LASS-II Rapid Geodetic Survey System (RGSS)

FINAL TECHNICAL REPORT

LASS-II RAPID GEODETIC SURVEY SYSTEM (RGSS)

Figure 4. CDU Modifications

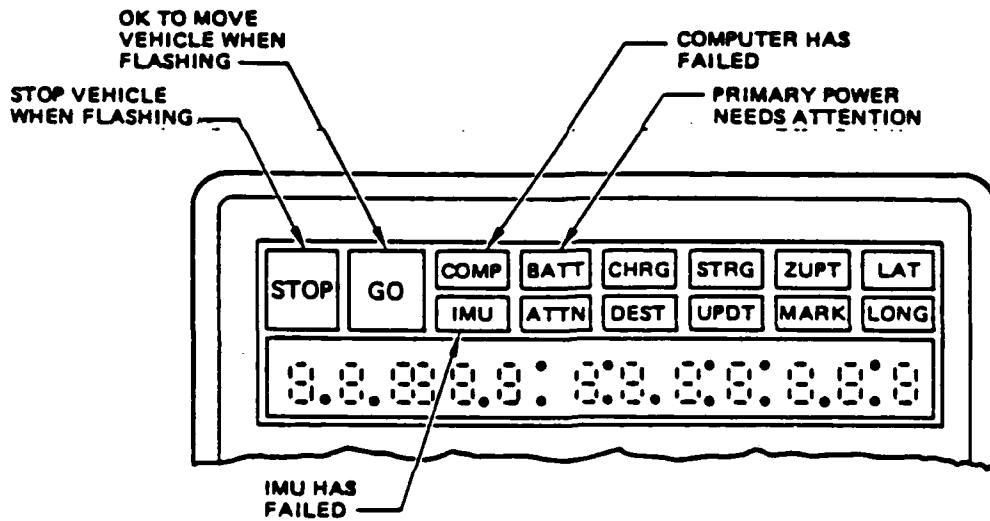
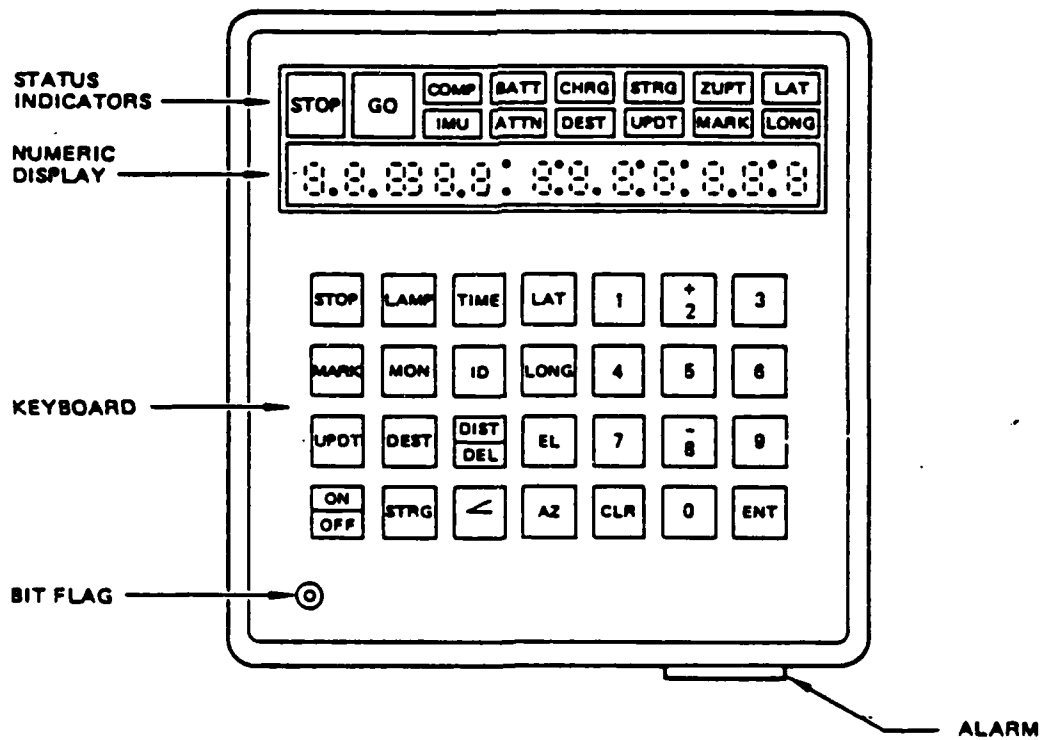
2.9.2 CDU Modifications. For CDU modifications, see figure 4.

SUBJECT: RGSS STABLE ELEMENT WIRING MODIFICATION

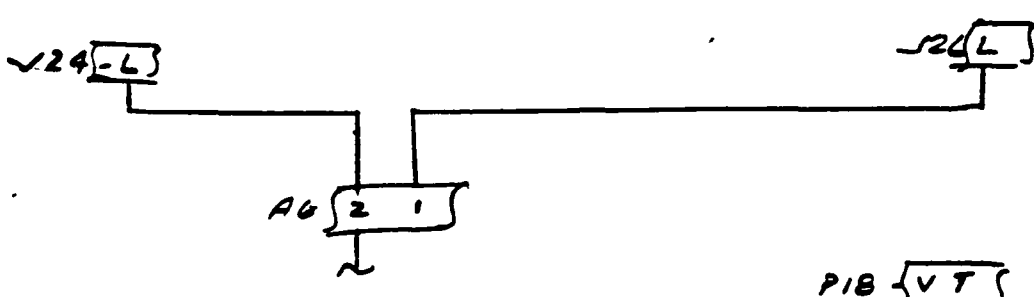
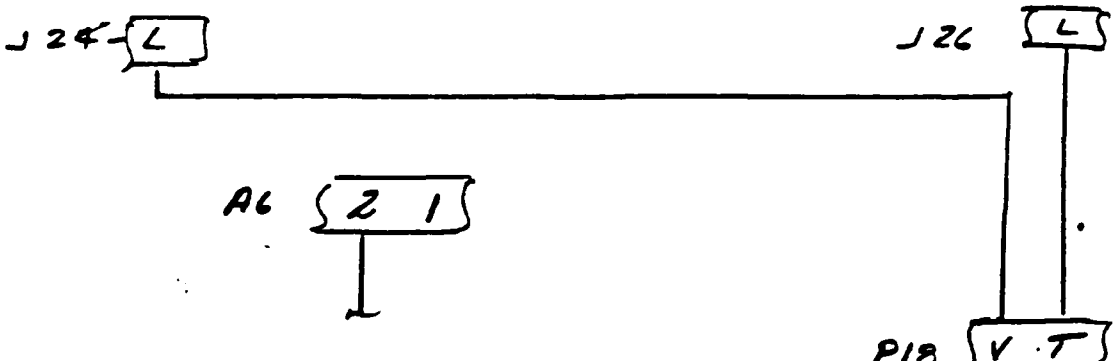
Add the following information to DFM 16.2/2

Remove wires from J24-L to A6-2
J26-L to A6-2

Add wires from J24-L to J18-V
J26-L to J18-T

Reason: Isolation of accelerometer scale factor returns
to quantizer. Reference ECN (Electrical Change
Notice) 143849 and 143850 (attached).

SCHEMATIC 867940 CHANGE FROM:**TO :**

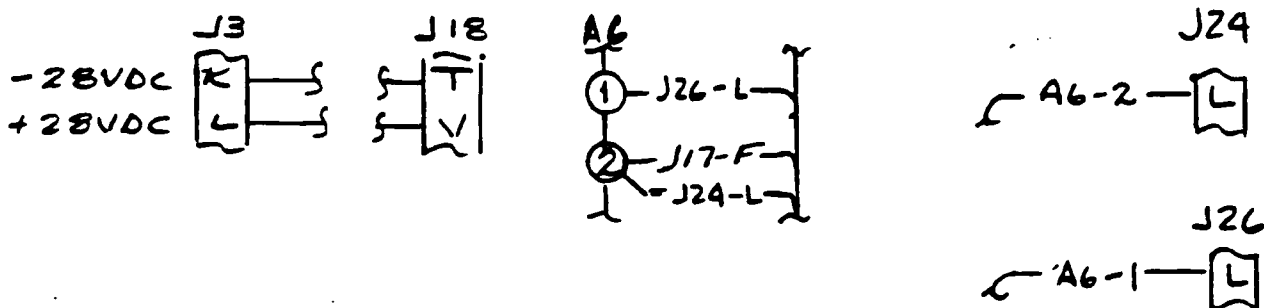
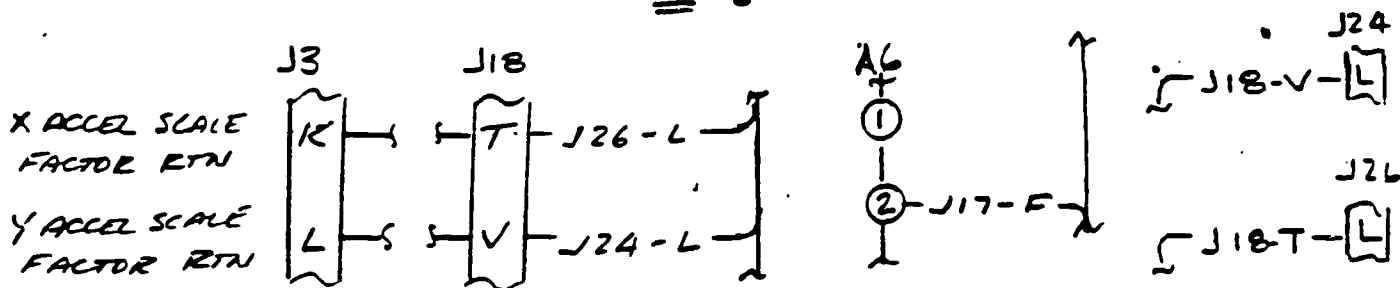
PROJECT RSS	UNIT IMU	MODULE S.E. Sub Assy	ASSEMBLY TO BE CHANGED 867941	SHEET 1 OF 1			
REASON FOR CHANGE ACCELEROMETER SCALE FACTOR RETURN ISOLATION REQUIRED							
DRAWINGS AFFECTED	SYSTEM YES NO	UNIT YES NO	MODULE YES NO	DRAWINGS AFFECTED	SYSTEM YES NO	UNIT YES NO	MODULE YES NO
SCHEMATIC CHANGE	<input type="checkbox"/> <input checked="" type="checkbox"/>	<input checked="" type="checkbox"/> <input type="checkbox"/>	<input checked="" type="checkbox"/> <input type="checkbox"/>	ARTWORK CHANGE	<input type="checkbox"/> <input checked="" type="checkbox"/>	<input type="checkbox"/> <input checked="" type="checkbox"/>	<input type="checkbox"/> <input checked="" type="checkbox"/>
ES/ATS CHANGE	<input type="checkbox"/> <input checked="" type="checkbox"/>	<input type="checkbox"/> <input checked="" type="checkbox"/>	<input type="checkbox"/> <input checked="" type="checkbox"/>	ASSEMBLY DWG CHANGE	<input type="checkbox"/> <input checked="" type="checkbox"/>	<input type="checkbox"/> <input checked="" type="checkbox"/>	<input type="checkbox"/> <input checked="" type="checkbox"/>

SCHEMATIC B67940 - CHANGE TO:

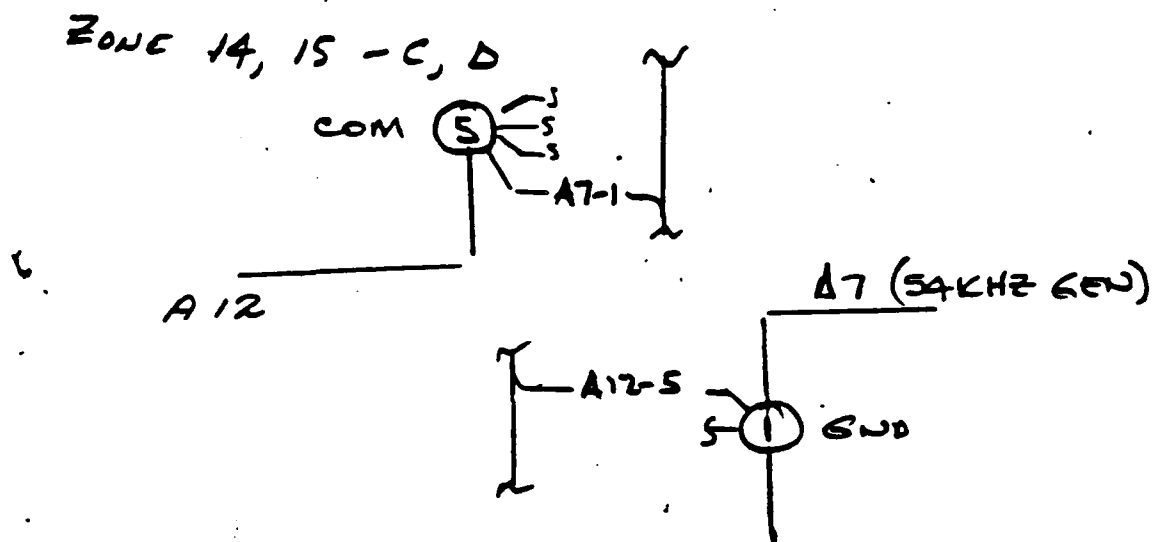
PROJECT RGSS	UNIT I-10	MODULE S.E.	ASSEMBLY TO BE CHANGED N.A.	SHEET 1 OF 1
-----------------	--------------	----------------	--------------------------------	-----------------

ZONE 14, 15 - C, D

Assy B64412 CHANGE FROM:

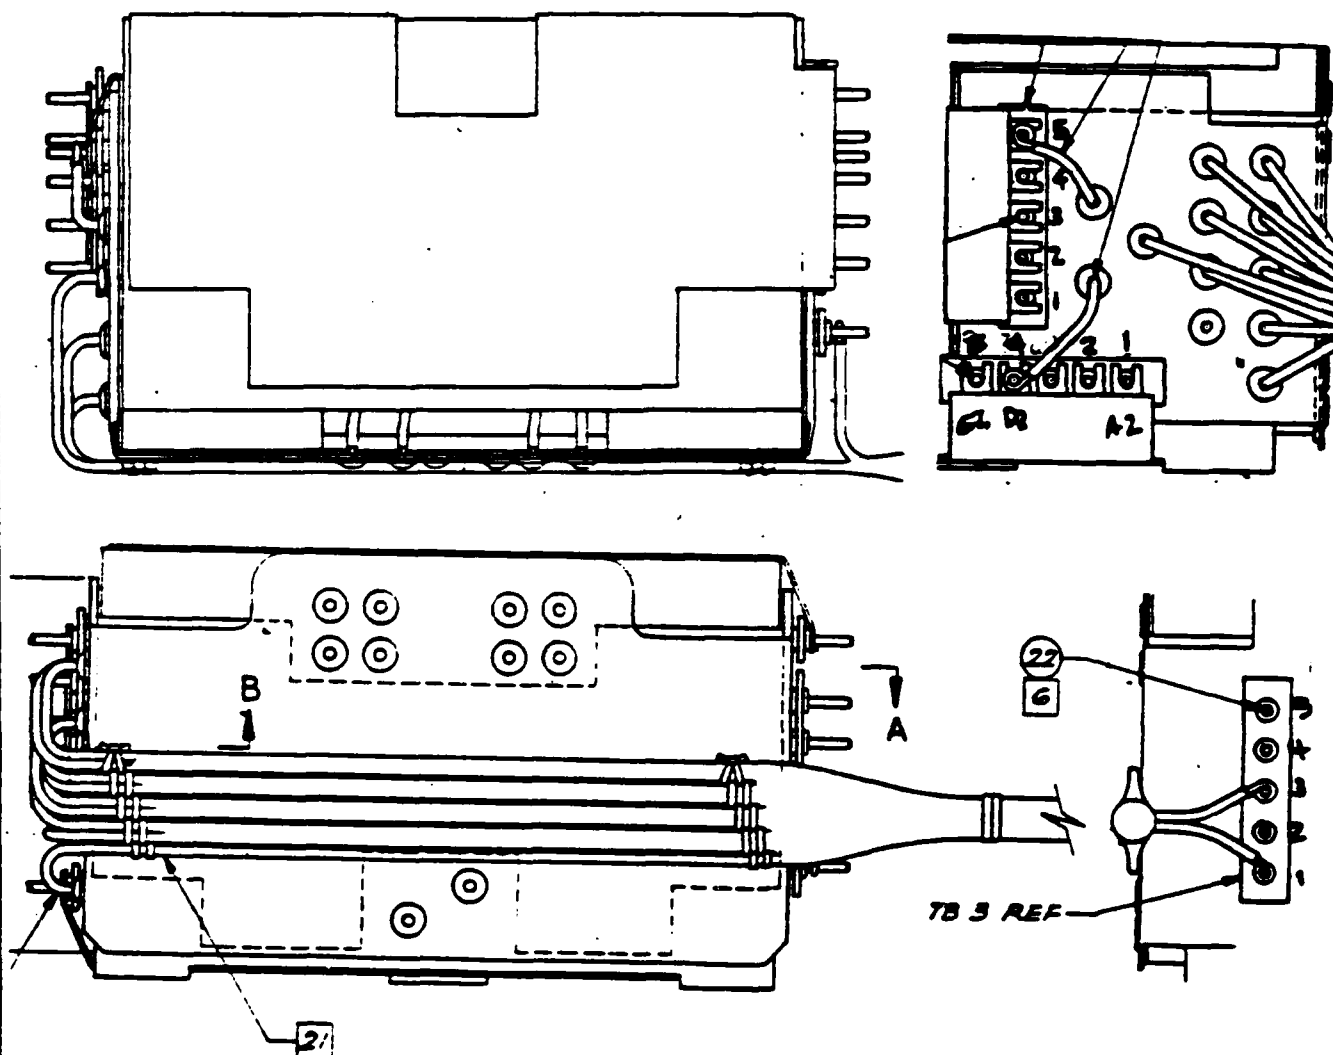
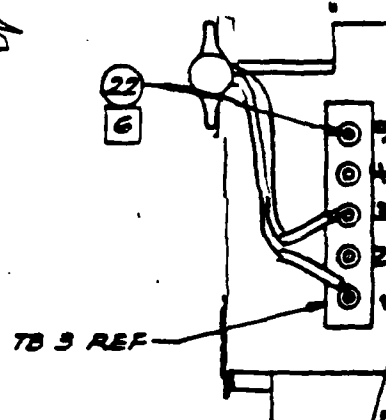
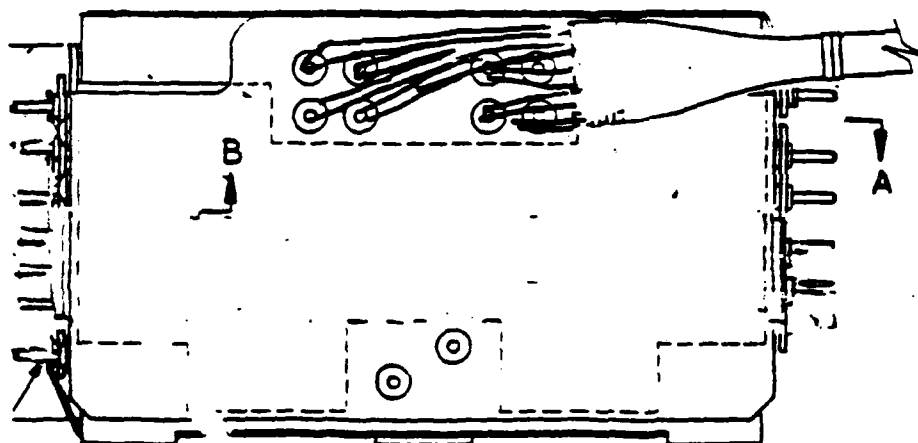
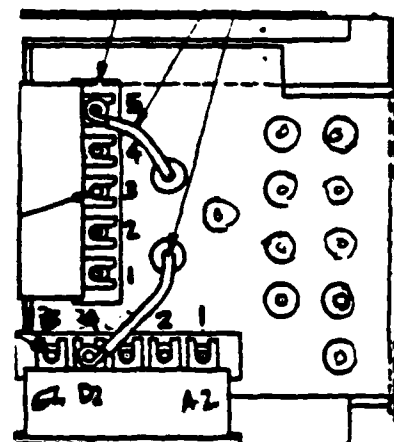
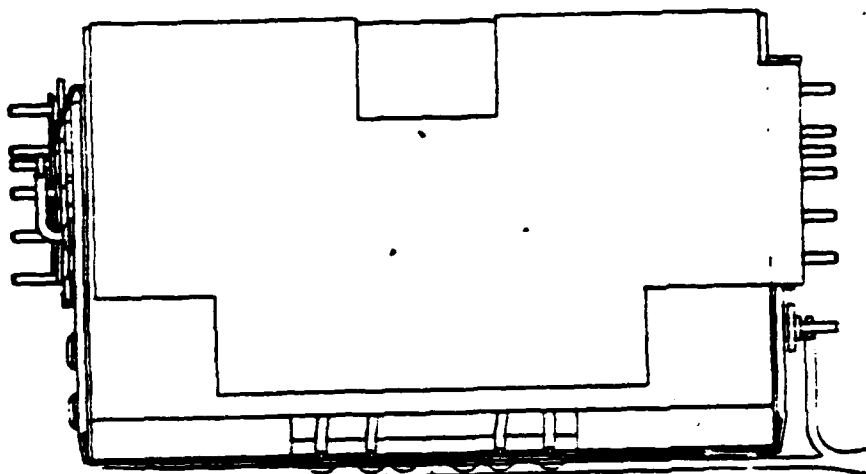
PROJECT RGSS	UNIT IMU	MODULE ACCEL	ASSEMBLY TO BE CHANGED 864412	SHEET 1 OF 1			
REASON FOR CHANGE ADDITIONAL CLEARANCE REQUIRED							
DRAWINGS AFFECTED	SYSTEM YES NO	UNIT YES NO	MODULE YES NO	DRAWINGS AFFECTED	SYSTEM YES NO	UNIT YES NO	MODULE YES NO
SCHEMATIC CHANGE	<input type="checkbox"/> <input type="checkbox"/>	<input type="checkbox"/> <input type="checkbox"/>	<input checked="" type="checkbox"/> <input type="checkbox"/>	ARTWORK CHANGE	<input type="checkbox"/> <input checked="" type="checkbox"/>	<input type="checkbox"/> <input checked="" type="checkbox"/>	<input type="checkbox"/> <input checked="" type="checkbox"/>
ES/ATS CHANGE	<input type="checkbox"/> <input type="checkbox"/>	<input type="checkbox"/> <input type="checkbox"/>	<input type="checkbox"/> <input checked="" type="checkbox"/>	ASSEMBLY DWG CHANGE	<input type="checkbox"/> <input checked="" type="checkbox"/>	<input type="checkbox"/> <input checked="" type="checkbox"/>	<input checked="" type="checkbox"/> <input type="checkbox"/>

DELETE NOTE [2] AND REFERENCE TO SAME

FILE: RGSS 16.0/3
DATE: 7 December 1984
SUBJECT: QUANTIZER MODIFICATIONS FOR CHANGE OF
LEVEL AXES ACCELEROMETERS

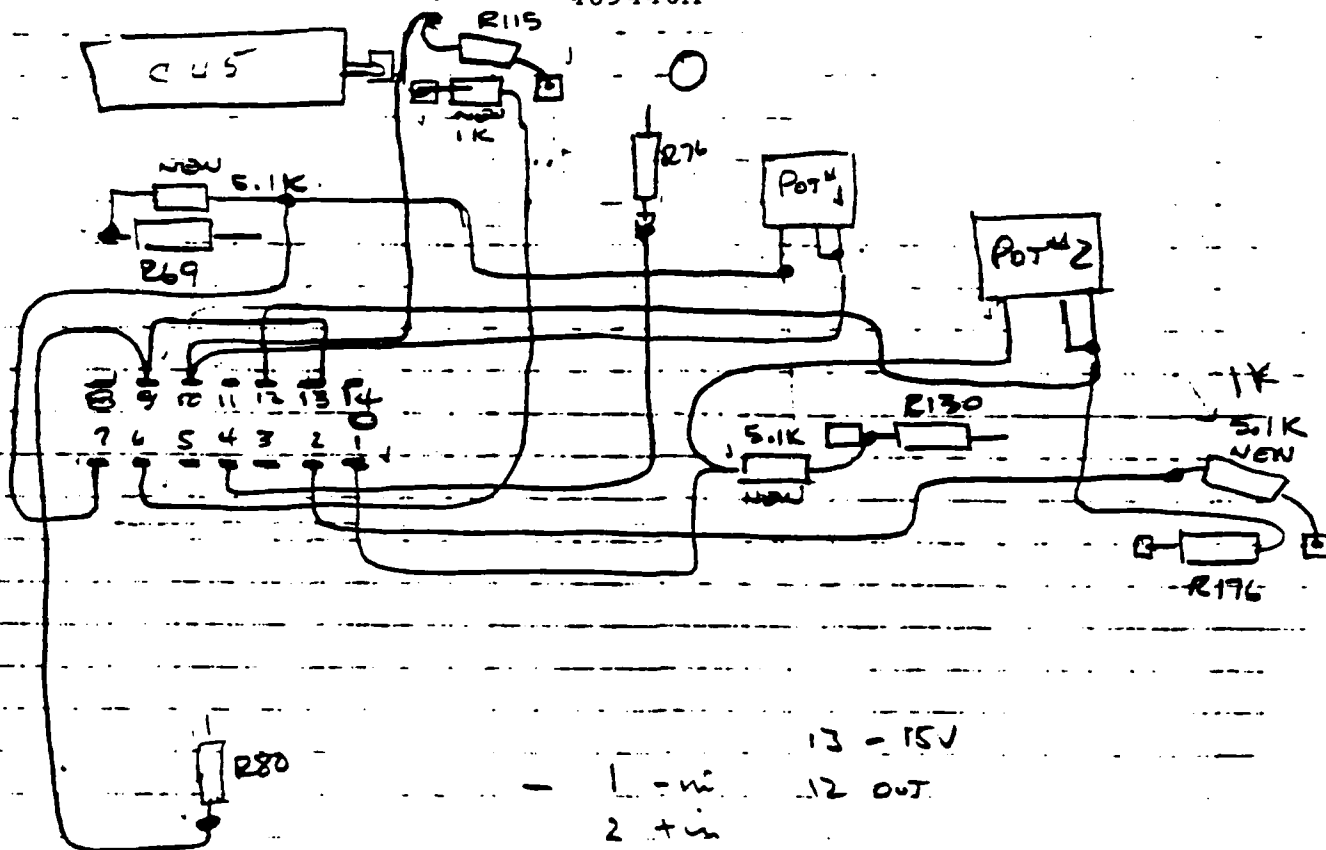
Changes to Quantizer assembly 880945 shall be made under "Demo Systems" ground rules, which include red lined drawings. The assembly shall be modified to accept the A1000 inputs for the level axes accelerometers in place of the present A200D accelerometers. The original Quantizer scaling accuracy, tracking and tolerances are to remain unchanged. The modifications are included in the red lined drawings attached. The drawings and areas of change are defined.

Remove C34, C35, C36
C60, C61, C62

Remove R112, R103, R164, R173

Remove R287, R284, R291, R295

Remove R111, R102, R163, R172

Remove R58, R119

Remove R289, R282, R290, R297

* Remove R288, R283, R291, R296

SCHEMATIC

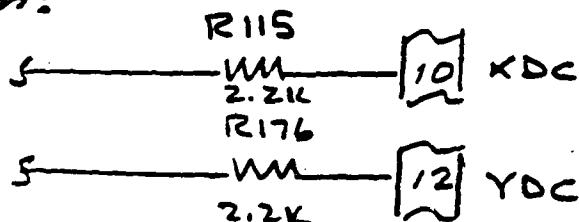
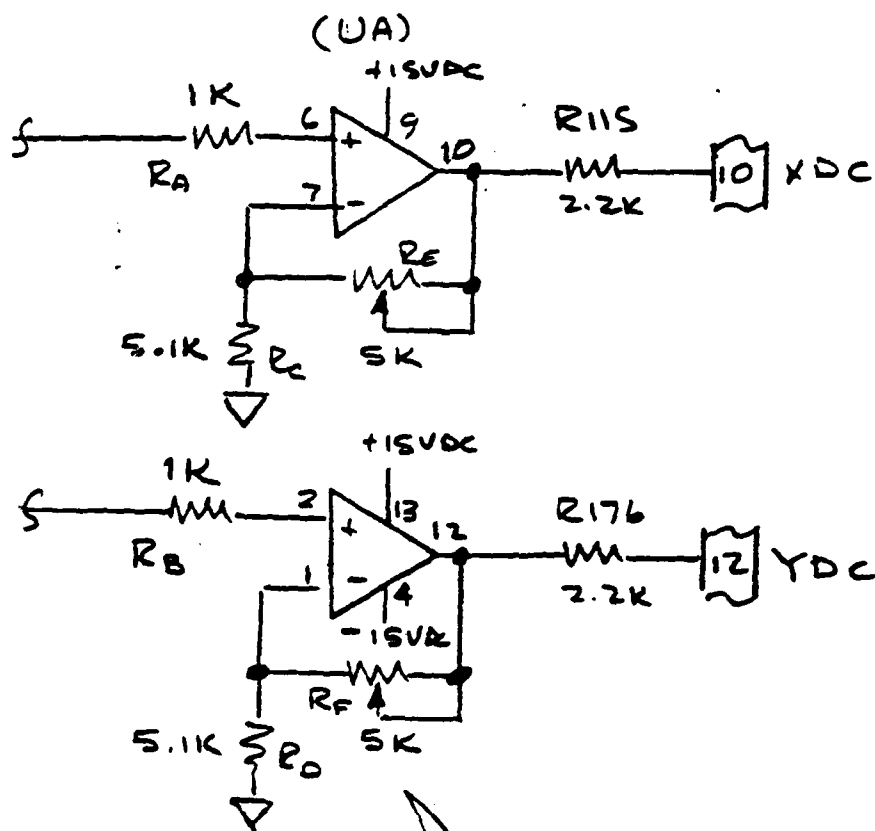
PROJECT K655	UNIT IMU	MODULE QUANTIZER	ASSEMBLY TO BE CHANGED	SHEET 1 OF 2
-----------------	-------------	---------------------	------------------------	-----------------

CHANGE FROM:

TO:

CHANGE ITEM 104 TO QTY 7 - ADD RA, RB
(944917-1001)

SCHEMATIC 880945

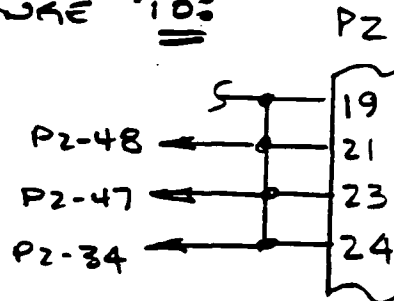
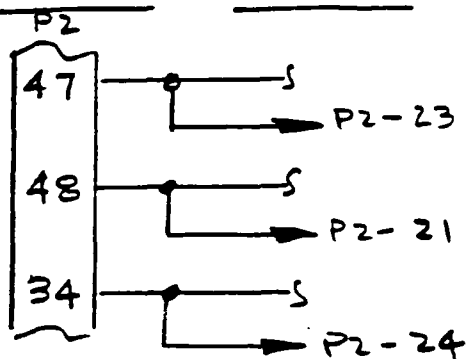
PROJECT RG SS	UNIT IMU	MODULE QUANTIZER	ASSEMBLY TO BE CHANGED 880945	SHEET 1 OF 1
------------------	-------------	---------------------	----------------------------------	-----------------

CHANGE TO:

ADD JUMPER
